# Minor Project Review

## 16-063MPR– Building C-2; Cap City

### BSD Scioto River Neighborhood District

This is a request for a modification to the previously approved site plan to fit a tenant space for the first floor of Building C2 within Bridge Park Development within the Bridge Street Scioto River Neighborhood District located on the east side of Riverside Drive. This is a request for review and approval of a Minor Project Review Application under the provisions of Zoning Code Section 153.066.

Approved Final Site Plan for Block C

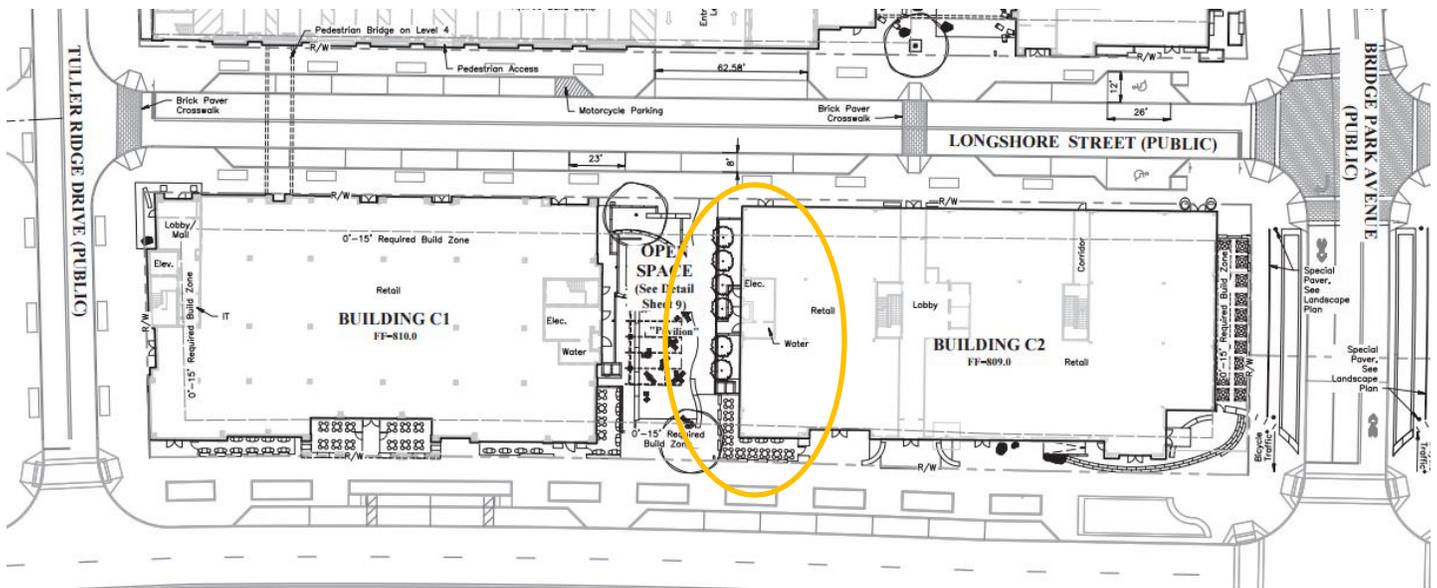
Staff inquired if encroachments were needed for the patio. *(Staff note: The approved final site plan for Block C illustrates the patio area as proposed by the applicant. See illustration below.)*
